ADDENDUM No. 1
LUC-2-22.51 NAVARRE / COY INTERSECTION IMPROVEMENT
PID 109596

CITY OF OREGON
DEPARTMENT OF PUBLIC SERVICE

CULVERT GENERAL PLAN AND LONGITUDINAL SECTION

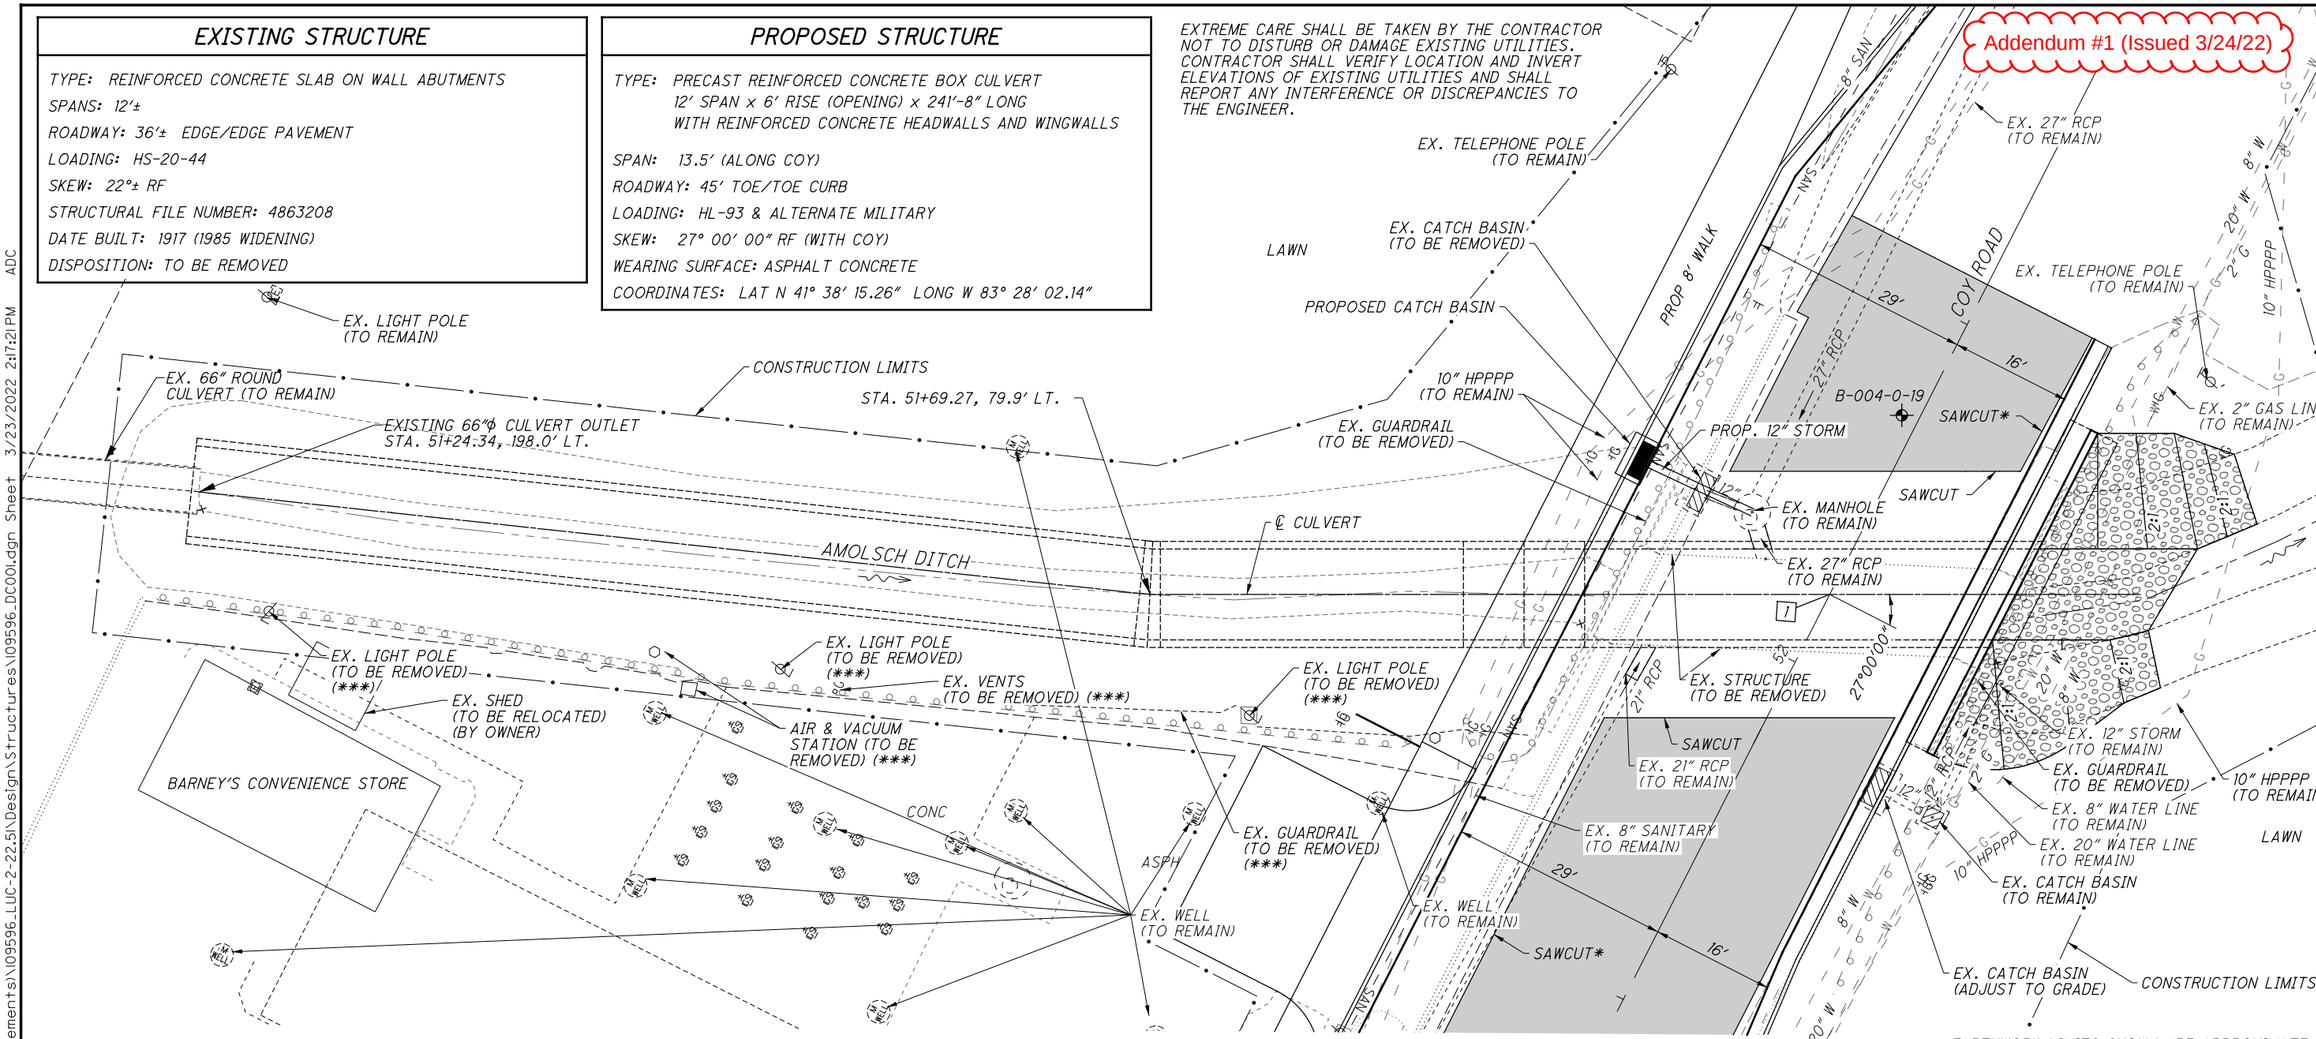
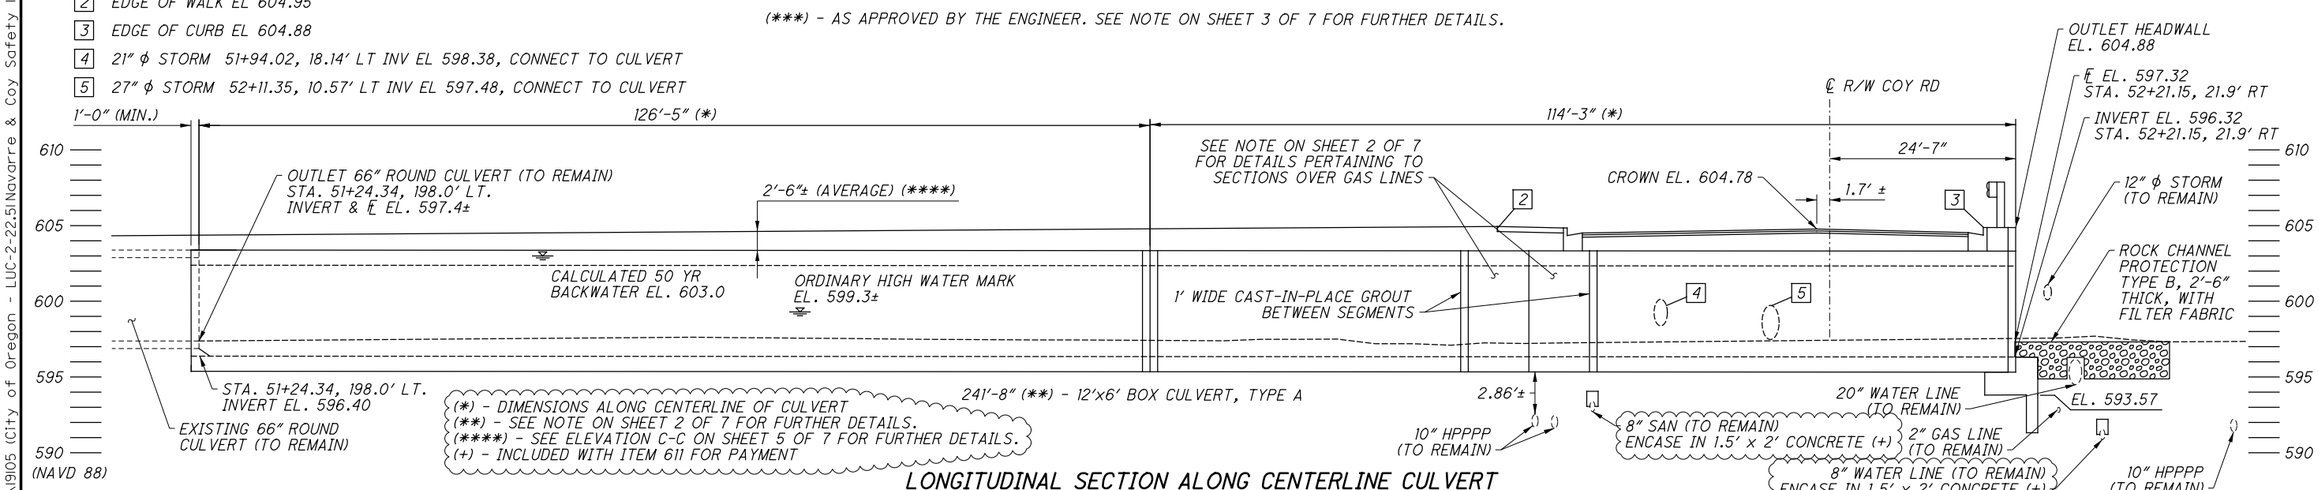
Question #2 - There is an 8" sanitary and 8" waterline to be encased in 1.5' x 2' of concrete. These are called out on sheets 59/118 and 102/118. Where are these items to be paid under?

See note on revised sheet 103.

CONCRETE ENCASEMENT FOR EXISTING 8" SANITARY AND 8" WATERLINE SHALL BE INCLUDED WITH THIS ITEM FOR PAYMENT. ENCASEMENT SHALL EXTEND 6 FEET BEYOND THE LIMITS OF THE PROPOSED CULVERT AND CONSIST OF CLASS QC MISC OR QC 1 CONCRETE. EXCAVATION REQUIRED FOR THE ENCASEMENT SHALL ALSO BE INCLUDED WITH THIS ITEM.

ALL MATERIALS, EQUIPMENT AND LABOR FOR THE CAST-IN-PLACE GROUT WORK AND EXISTING PIPE CONCRETE ENCASEMENT IS TO BE PAID FOR WITH ITEM 611, 12' X 6' CONDUIT, TYPE A, 706.05, AS PER PLAN.
